Memo

Application: DP10-0093/DVP10-0094

Address: 1290/1298 St. Paul Street

Subject: Development Permit & Development Variance Permit

PROJECT TITLE: Sole on St. Paul
DRAWING TITLE: Parkade - 2nd Floor
PROJECT NO.: 10546

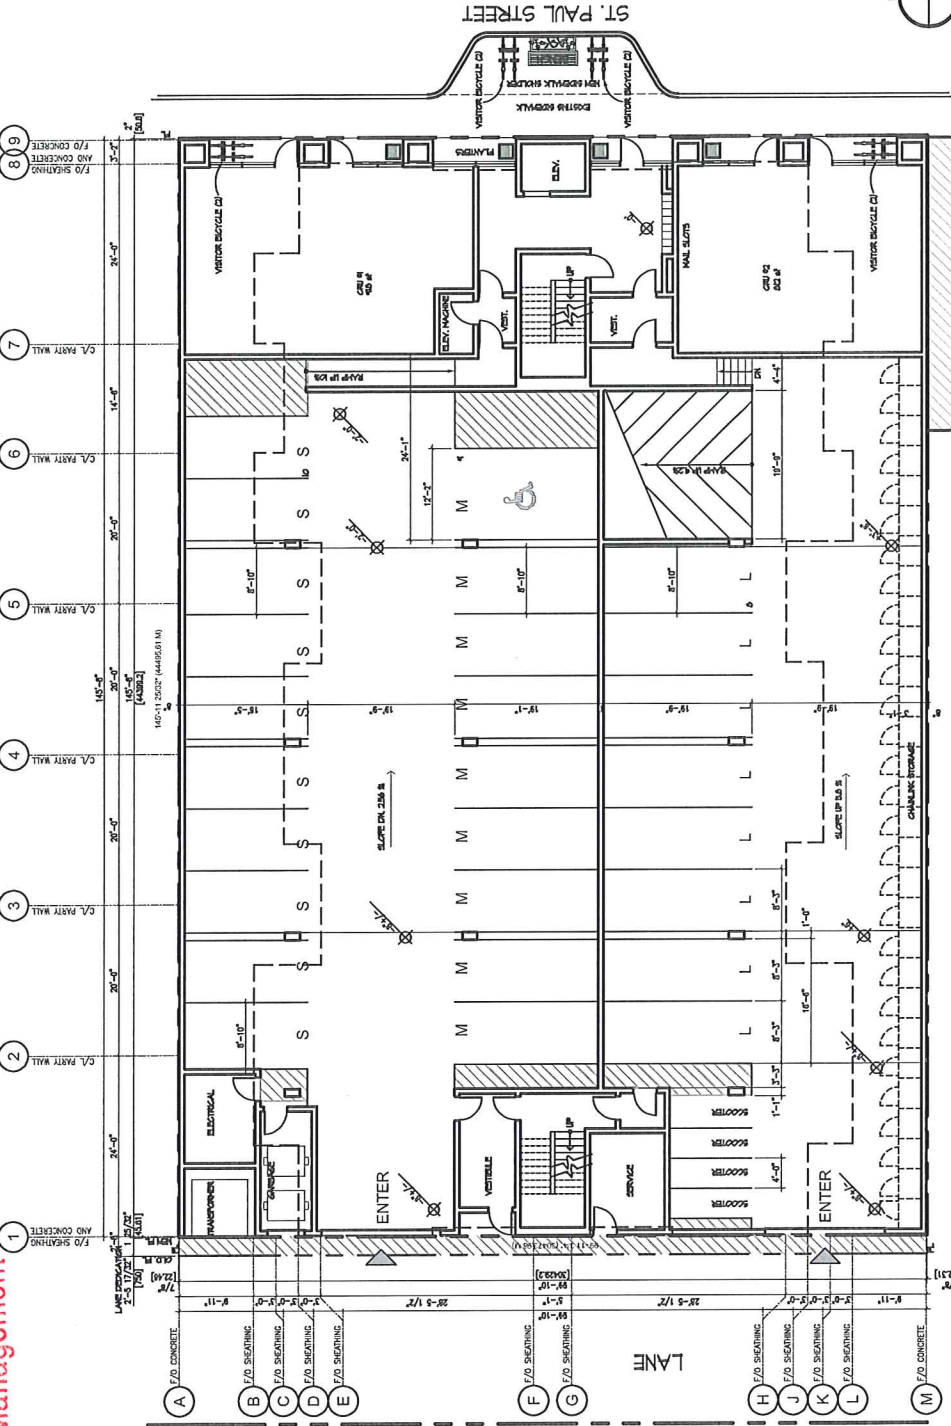
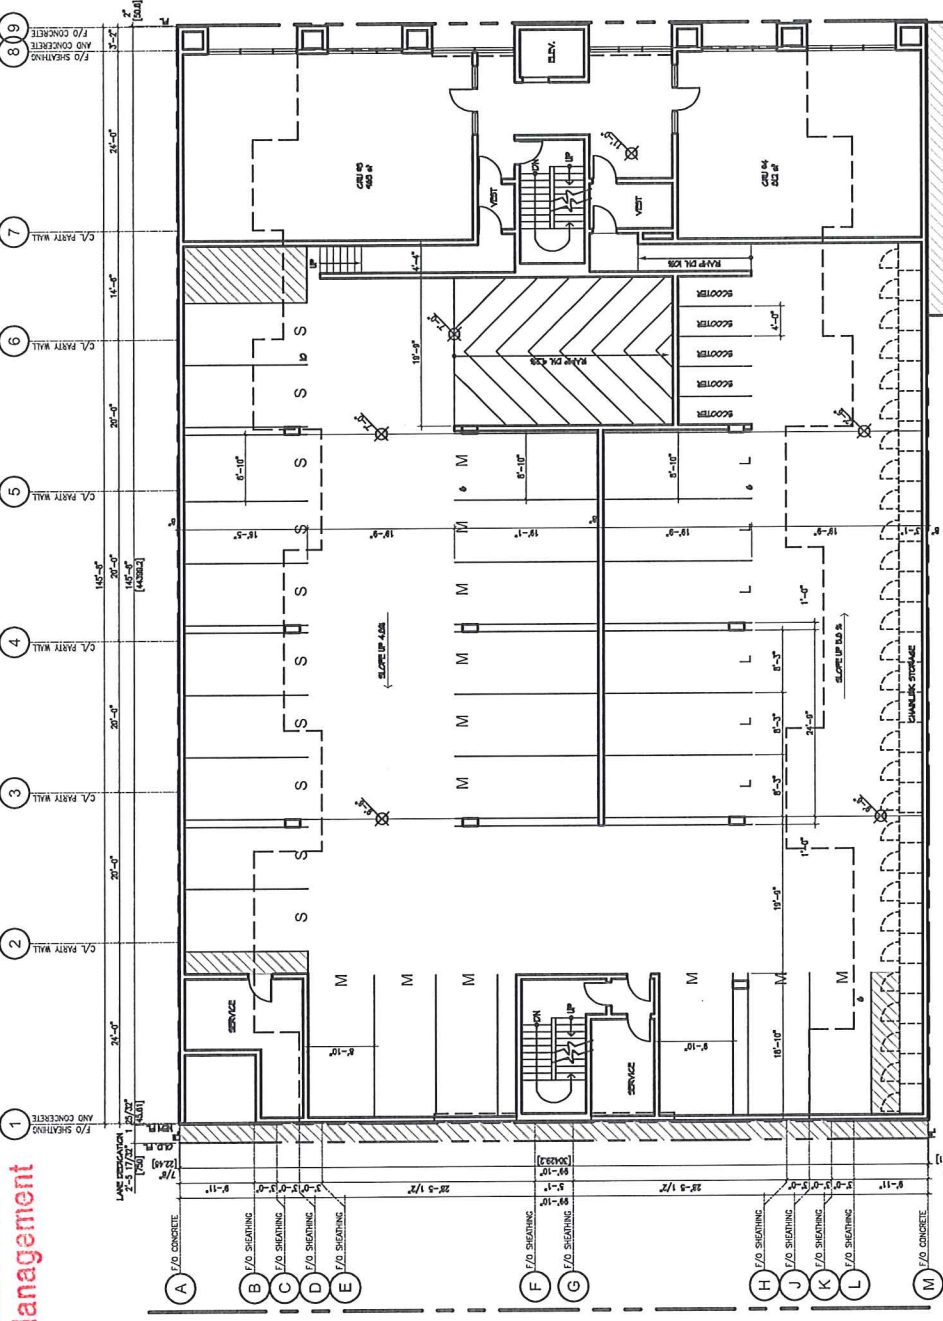
- A total of 59 parking spaces are required for the project, 54 for the residential component, and 5 for commercial. While only 56 stalls are proposed, the applicant is proposing to utilize available parking credits identified in Council Policy #314 (Parking Credits for Mixed Use Development Within the Downtown Urban Centre) to waive the commercial parking component. The application of the parking credits allows the project to comply with the parking requirement. The credit program is administered through the Development Variance Permit process. The proponents have also committed to a car-share program to be included in the project, which provides further parking relief. The car-share will be available for both building residents and the general public.

- The percentage of small car stalls from a maximum of 40% to 75% proposed. As shown in the attached parking summary, there are a number of stall depths proposed, however, only 25% of the parking stalls are a full 6.0m in depth.

⑤ Variance required for parking stall depth. 25% of stalls are conventional depth. The remaining stall depths range from 5.0m to 5.8m (see attached parking analysis).

THAT the Advisory Planning Commission NOT support Development Variance Permit Application No. DVP10-0094, for 1290 & 1298 St. Paul Street, to vary the small car parking stall size from 2.5m x 5.5m required to 2.3m x 4.6m proposed.

THAT the Advisory Planning Commission NOT support Development Variance Permit Application No. DVP10-0094, for 1290 & 1298 St. Paul Street, to vary the parking stall size from 2.5m x 6.0m required to 2.5m x 5.0m proposed.

The Advisory Planning Commission did not support the Development Variance Permits as some of the Members believed that the proposed size would not accommodate a mid to full size vehicle. Some of the Members commented that the parking stall variances went too far and that the Applicant should have only requested that a portion of the stalls be varied, or that the number of "small car" stalls already allowed for in the Zoning Bylaw be varied. The Members expressed a concern with the Applicant's suggestion that the sale of the parking stalls would be separate and apart from the sale of the residential units and recommended that City staff consider an agreement to ensure that the owners of the units in the development were given preferential rights with respect to any sale of the parking stalls.

Section 8.1.2 - Number of Parking Spaces: To vary required amount of parking spaces (as per Table 8.1) from 59 required to 56 proposed (as per Council Policy #314);

Section 8.1.11(a) - Parking Stall Size: To vary the amount of parking spaces permitted which are of a length shorter than 6.0m from a maximum of 40% allowed to 75% proposed;

Section 8.1.12 - Parking Aisle Width: To vary the minimum two-way aisle width from 7.0m allowed to 6.0m proposed;

SOUTH ELEVATION

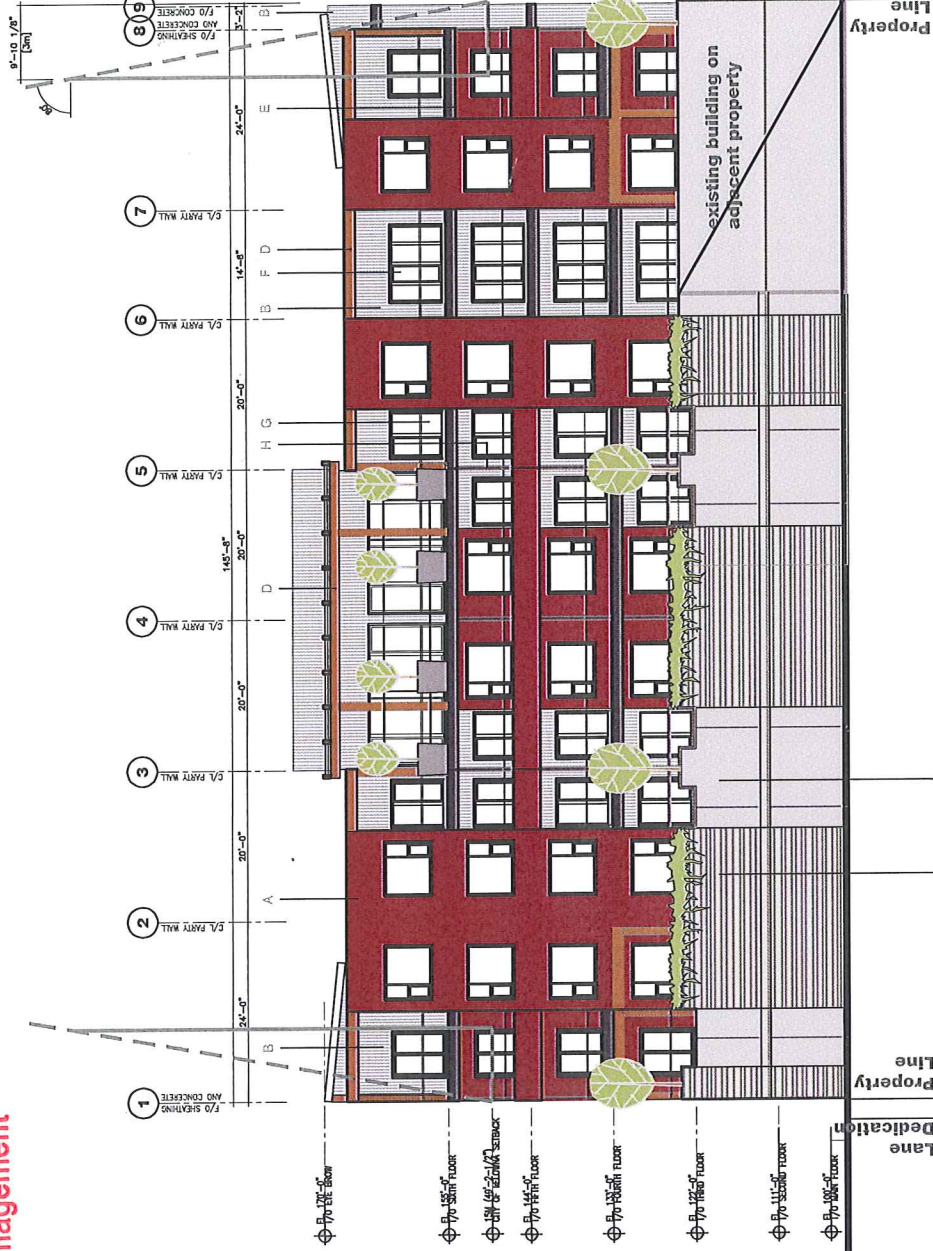
However, the proposed variance for building setback above 15.0m impacts both the St. Paul and laneway elevations. Of note, this could impact residents of the existing development to the west at the Cannery Lofts (1289 Ellis Street). The applicant has stated that aside from the issue of affordability, the narrow lot frontage is a challenge that has led to portions of the upper storeys being designed within this required setback. While the proposed variance does not represent a substantial deviation from the Zoning Bylaw, it is a precedent that cannot be supported by the Land Use Management Department.

- The C7 zone requires any portion of a building above 15.0m in height to be a minimum of 3.0m from any property line abutting a street. The requested variance would eliminate the setback requirements, as portions of the building above 15.0m at both the St. Paul Street and laneway elevations are proposed at 0.0m from property line (see north and south elevations attached).

THAT the Advisory Planning Commission NOT support Development Variance Permit Application No. DVP10-0094, for 1290 & 1298 St. Paul Street, to vary the front and rear elevations of a portion of the building above 15.0m from 3.0m required to 0.0m proposed.

The Advisory Planning Commission did not support the Development Variance Permit as the Members felt it would set a bad precedent and that because of the variance, the development was not aesthetically pleasing. The Members also expressed a concern that the shadowing that could occur on the street from the development is unknown at this time.

Section 14.7.5 - C7 Development Regulations: To vary minimum setback requirement for any portion of a building above 15.0m from 3.0m required to 0.0m proposed;
